SSES-FSAR

QUESTION 211.1

SUSQUEHANNA STEAM ELECTRIC STATION
UNITS 1 AND 2
FINAL SAFETY ANALYSIS REPORT

FSAR FIGURE 211.179-1

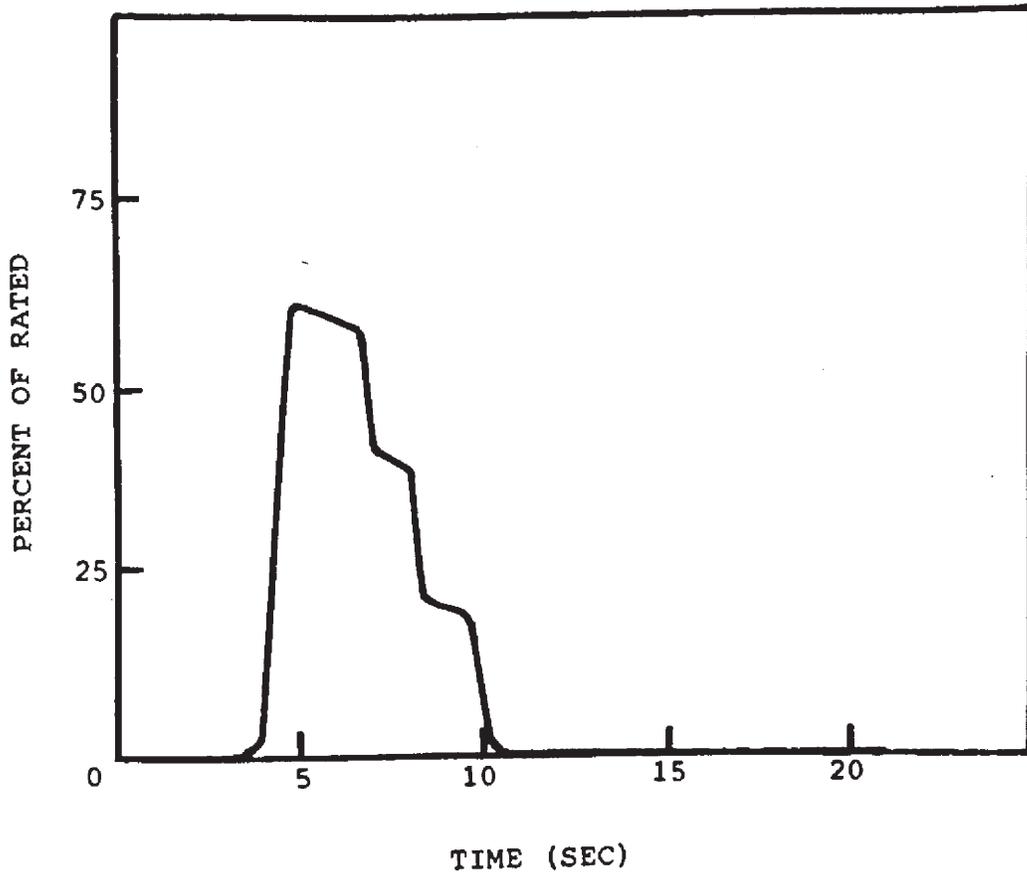
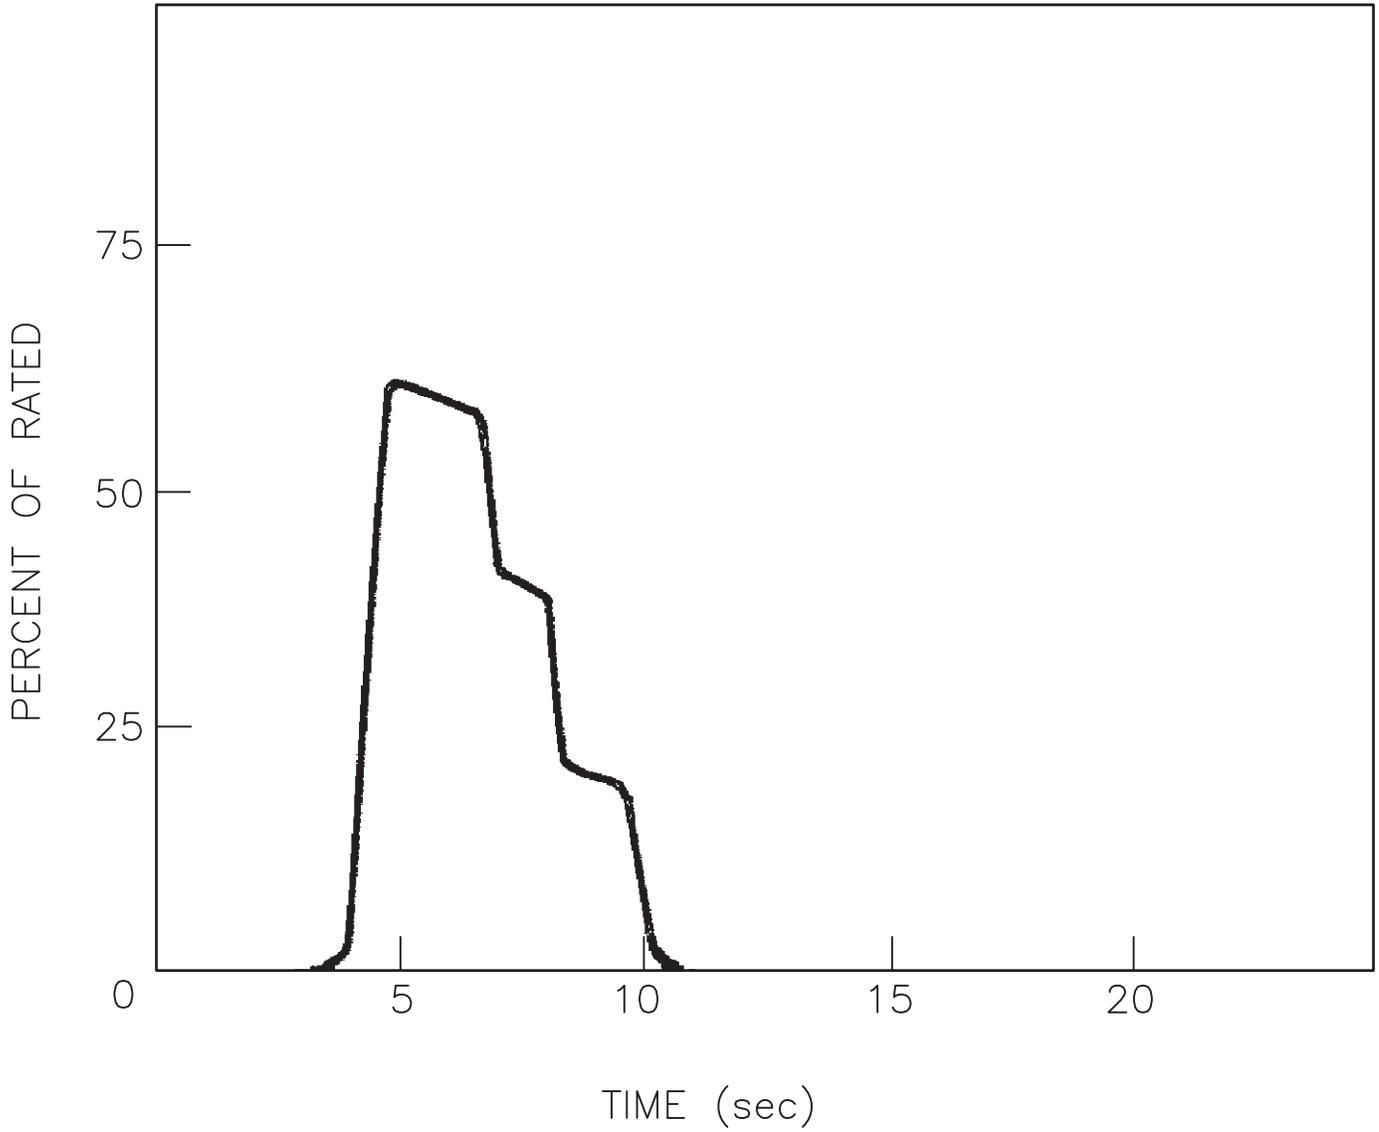
- a) Table 15.3-3 indicates that zero steam flow should not occur until after 41.7 seconds for the "seizure of one recirculation pump" transient. However, Figure 15.3-3 indicates zero steam flow at approximately 35 seconds. Explain this discrepancy.
- b) Include relief valve flow in Figure 15.3-3.

- a) Table 15.3-3 is modified to indicate zero steam flow at 35 seconds when bypass valve closes under control of the pressure regulator.
- b) Relief valve flow is indicated in Figure 15.3-3. The upper left quadrant indicates total steam flow and the upper right quadrant indicates total bypass flow after the turbine valve has been closed. Therefore, the difference is safety/relief valve flow. Relief valve flow is shown in Figure 211.179-1.

FSAR FIGURE 211.227-1

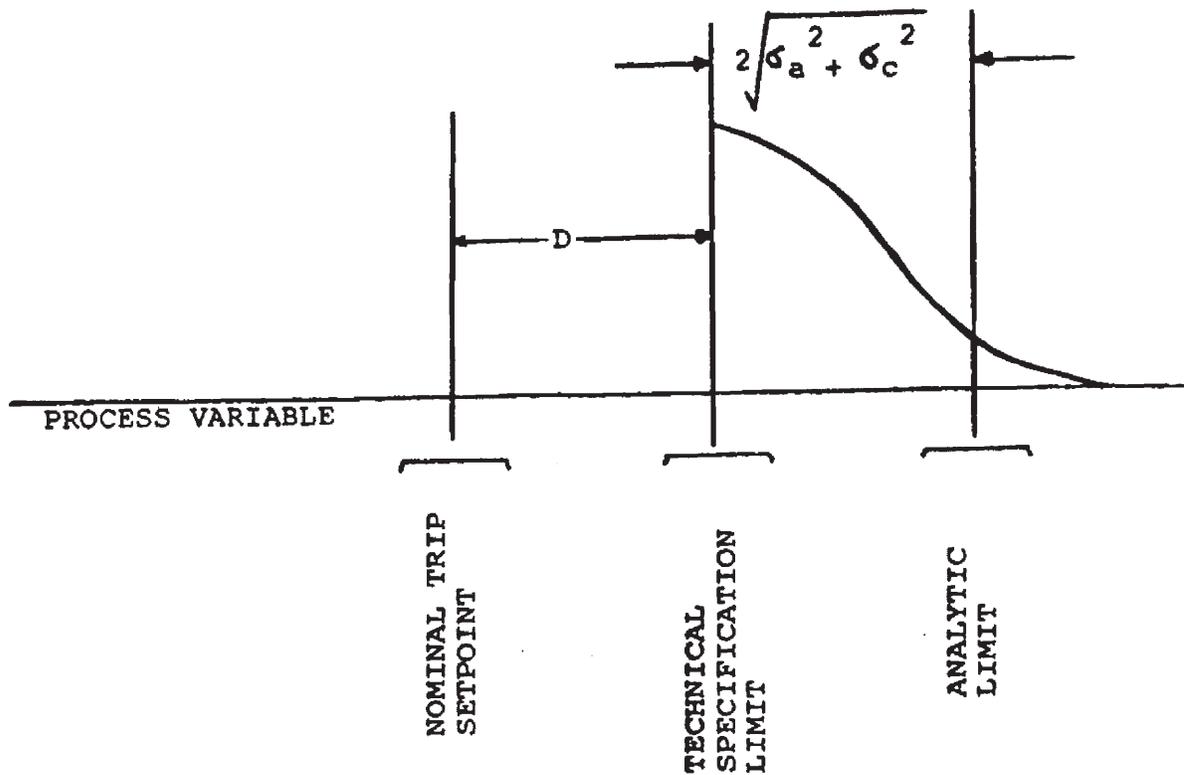
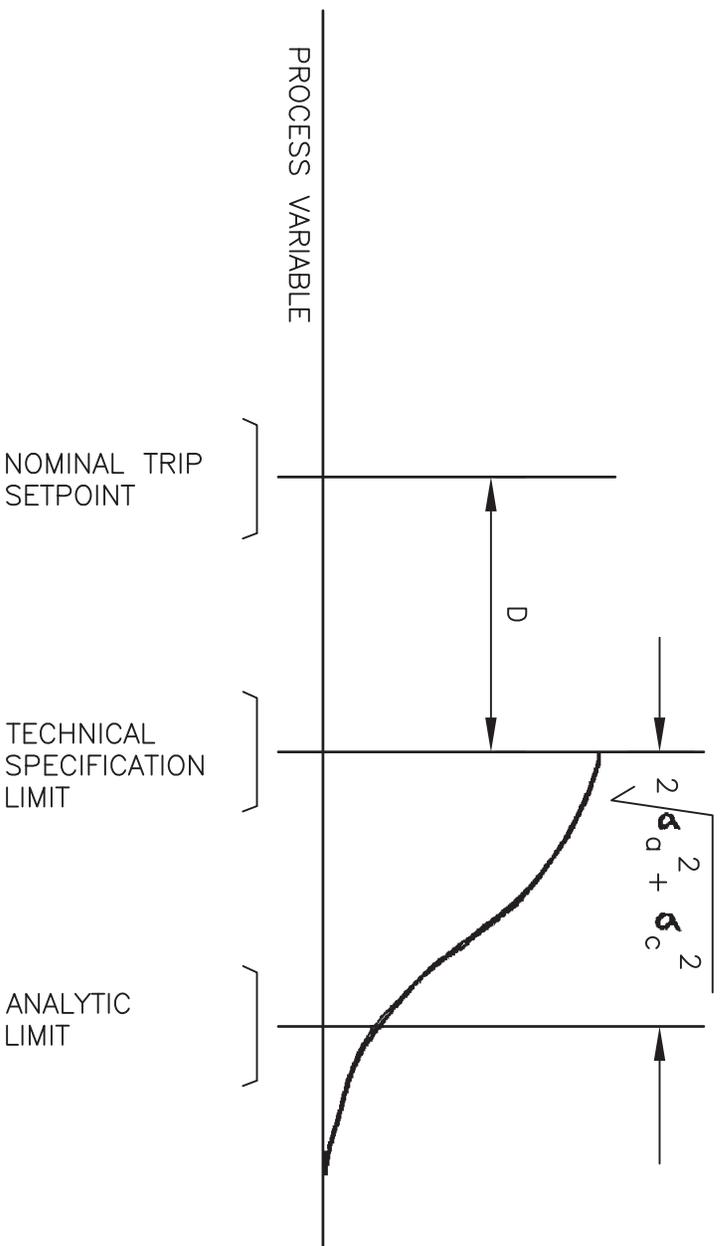
Provide the trip settings and setpoint ranges for the RCIC system isolation instrumentation. Indicate the method of specification of these settings and the provisions for minimizing the potential for inadvertent isolation of RCIC.

RCIC system isolation instrumentation trip setting and setpoint ranges are provided in the plant Technical Specifications. The trip setpoints are established from the analytic limit by allowing for instrument drift and accuracy and calibration capability (see Figure 211.227-1).
